**Re: Initial Submission Advisory Site Plan Review – APS P8 School at Harmony-  
Advisory Site Plan**

Application Number: **DA-1925-07**  
Case Number(s): **2018-6039-00** Dear Ms.Martini

## *Initial Submission Contextual Site Plan and Plat Review*

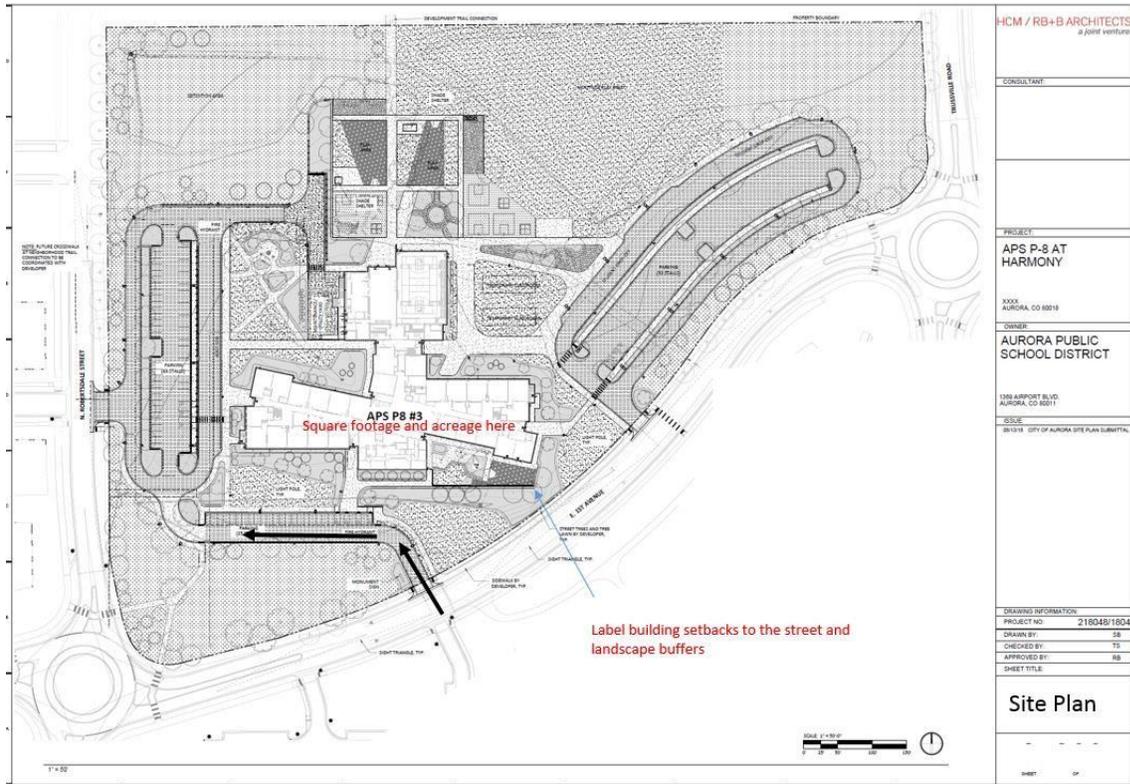
2A. Please include a “ Site Plan” page in the Site Plan set to show the information called out in the image below. Please turn off the landscape layers on the “ Site Plan” page and be sure to call out building setbacks and landscape buffers on this sheet.

**Response: The Site Plan has been incorporated into the Horizontal Control Plan (sheet C3). Per the “Public School Development Process Agreement with the Aurora and Cherry Creek School Districts” (IGA) building setbacks and landscape buffers are not required, and therefore are not included on the plan.**
